CITY OF SAINT PAUL
Melvin Carter, Mayor

DATE: June 15, 2020
TO: Comprehensive & Neighborhood Planning Committee
FROM: Bill Dermody, City Planner
RE: RM Zoning Study

Example 2: Existing building with R4 zoning, but anticipate (hopeful for) future RM2 zoning, as it's half a block from the A-Line stop at Minnehaha and Snelling.

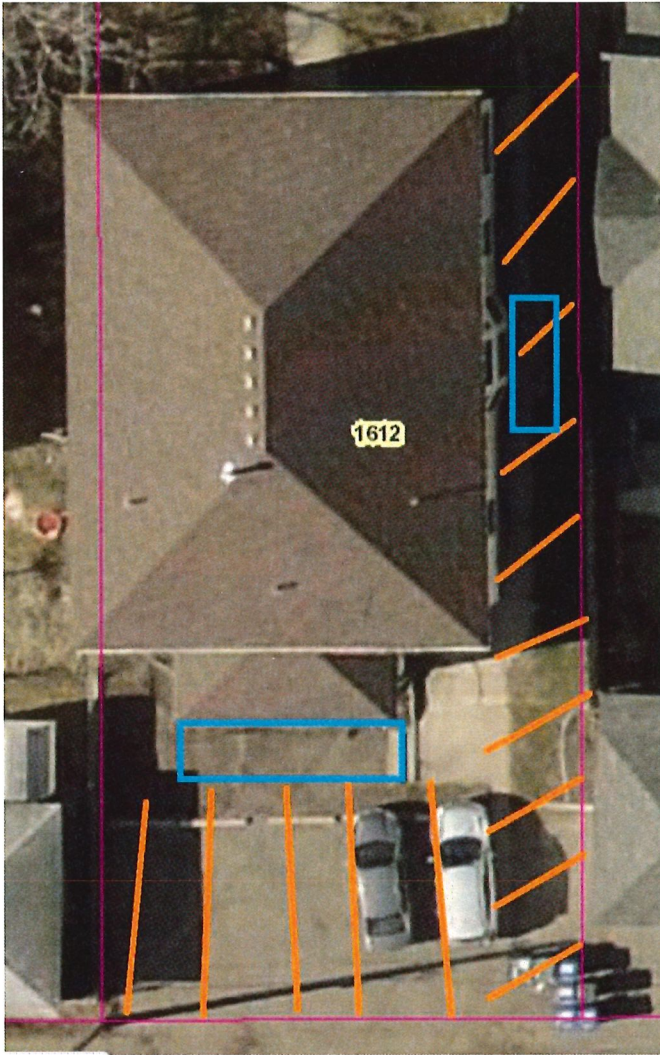
I was hoping to be able to use some of my front and side yard to expand the building to provide more housing. A reduced front setback would more easily allow me to add a 2nd and 3rd floor deck off the front of the apartments that overlook Iris park directly ahead (which would be an attractive feature).

If a 9ft side yard setback remains in place, the most I could expand in the red outline is about 11ft to the side and 10ft to the front because I would need additional space in the blue area for a 6ft wide (minimum) stairway. This would mean that the addition to the building would not accommodate any additional units and not be worth the investment.

1612 Van Buren Avenue

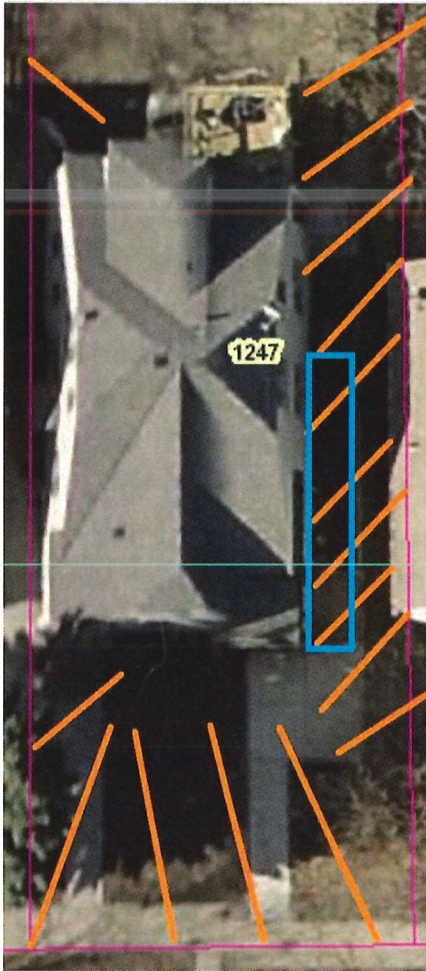
The orange lines show how the 9ft side and rear-yard setback eliminate the possibility expansion.

The blue boxes indicate where I'd like the option of building steps/decks to the 1st and 2nd floors to accommodate additional apartments. I have no option on the side yard, and have a very tight fit on the rear and would likely need to request a variance of a few feet unless I want to try to create a crazy spiraling staircase in the space off to the right and a narrow walkway along the back, which would be ugly.
